Subject: Byron Station Units 1 and 2
Loss of Offsite Power - Request
for Additional Information

Byron/Braidwood Units 1 & 2
NRC Letter Dated June 27, 1988

Loss of Offsite Power Followup Request for Additional Information

FIGURE 1
BYE/BEARWOOD units 1 & 2

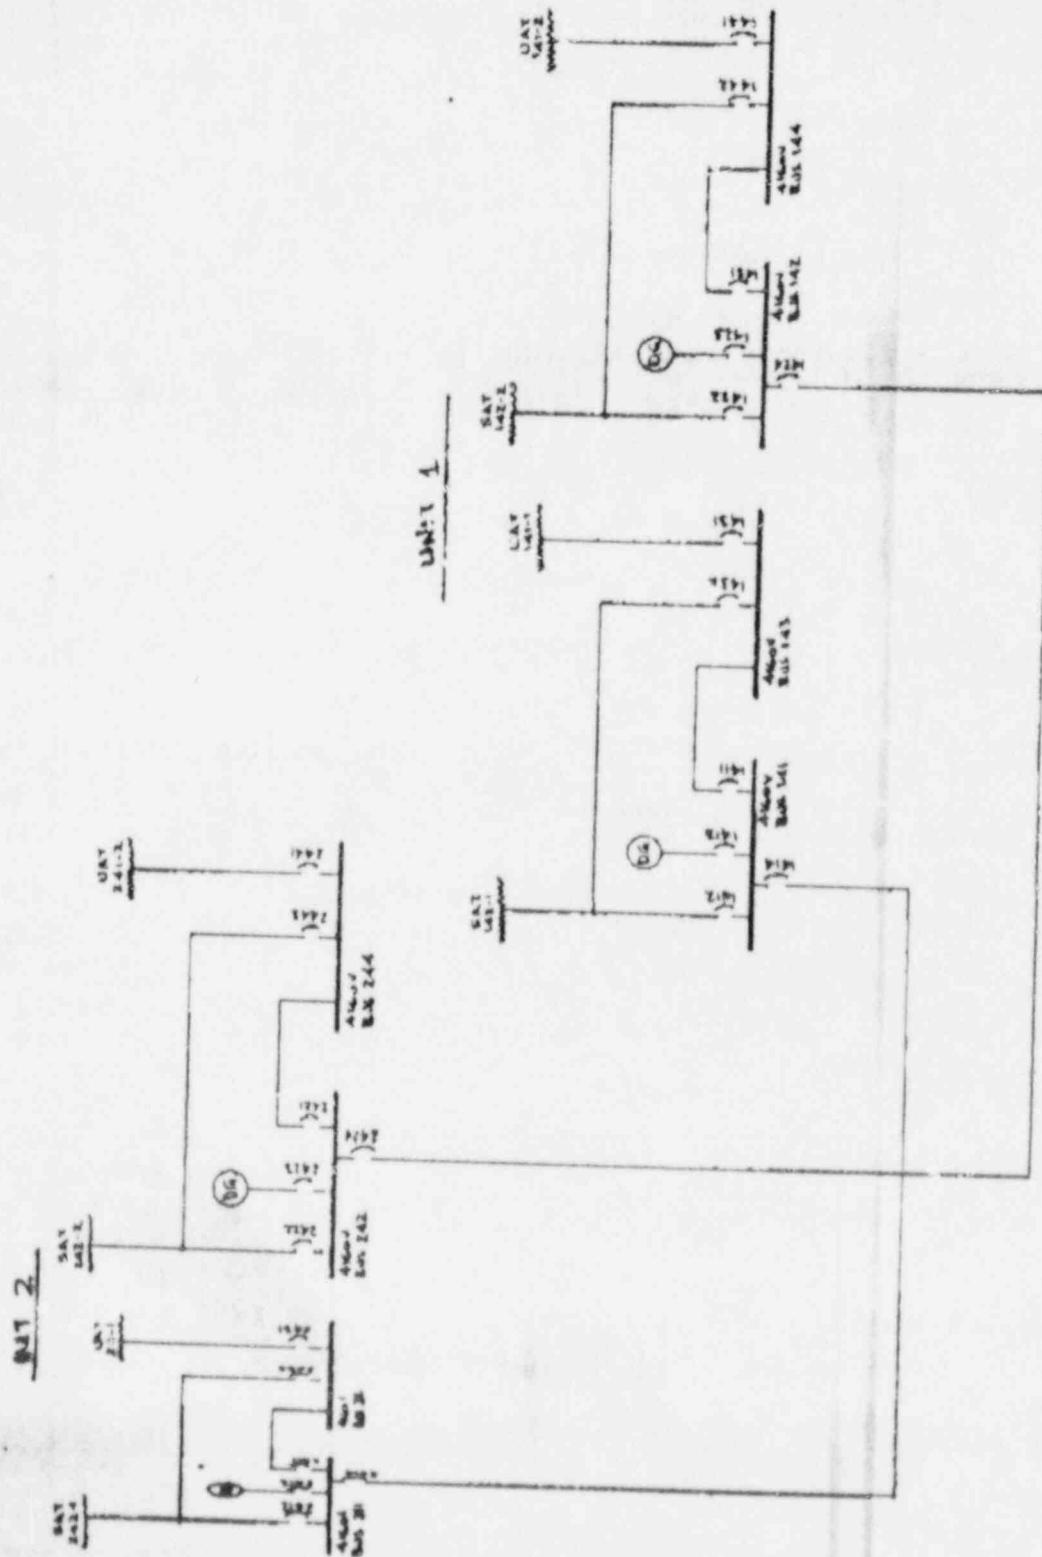
The enclosure in the subject NRC letter states that "both units normally operate from their unit auxiliary transformers. One of two offsite sources feeding through each unit's SAT serves as the normal immediate access feed to the ESF divisions of that unit; each unit's SAT then can provide the second source of power for the other unit through its ESF buses by operator action (delayed access)."

The above NRC statement indicates a misunderstanding of the Byron/Braidwood Auxiliary Power System configuration and design (e.g., the Class 1E buses do not normally operate from the unit auxiliary transformers but from the system auxiliary transformers). Therefore, in the interest of clarifying the Byron/Braidwood design prior to addressing the concerns raised by the NRC, we are first providing a brief description of the 4160V Class 1E Auxiliary Power System followed by the requested information regarding the ratings of the Class 1E 4160V buses and main breakers.

Figure 1 is a simplified single line diagram of the 4160V Auxiliary Power System installed at Byron/Braidwood Stations, Units 1 & 2. There is no provision for feeding a Class 1E 4160V bus from a Unit Auxiliary Transformer (UAT). The controls for the tie breakers between the Class 1E and non-Class 1E buses (i.e., breakers 1411, 1421, 2411, and 2421 in Figure 1) are interlocked so that they may be manually closed (to provide diesel-generator power to selected non-1E loads) only when (a) the UAT and SAT breakers of the non-1E bus are open, and (b) the Class 1E bus unit cross-tie breakers are open (e.g., breakers 1431, 1432, and 1414, must all be open in order to close Breaker 1411).

In each case, power is supplied to the 4160V Class 1E bus either (normally) by the associated System Auxiliary Transformer (SAT) of the unit, by automatic transfer to the diesel-generator upon loss of the SAT, or by manual transfer to the second source of offsite power (i.e., the associated SAT of the other unit) through the 4160V Class 1E switchgear cross-tie breakers.

Each pair of SATs is sized to provide the total auxiliary power for one unit, plus the Class 1E auxiliary power for the other unit. In addition, each of the two SATs is available (through the 4160V Class 1E switchgear cross-tie breakers) to all safety-related loads of one division for both units and, therefore, serves as the second source of offsite power to the other unit.
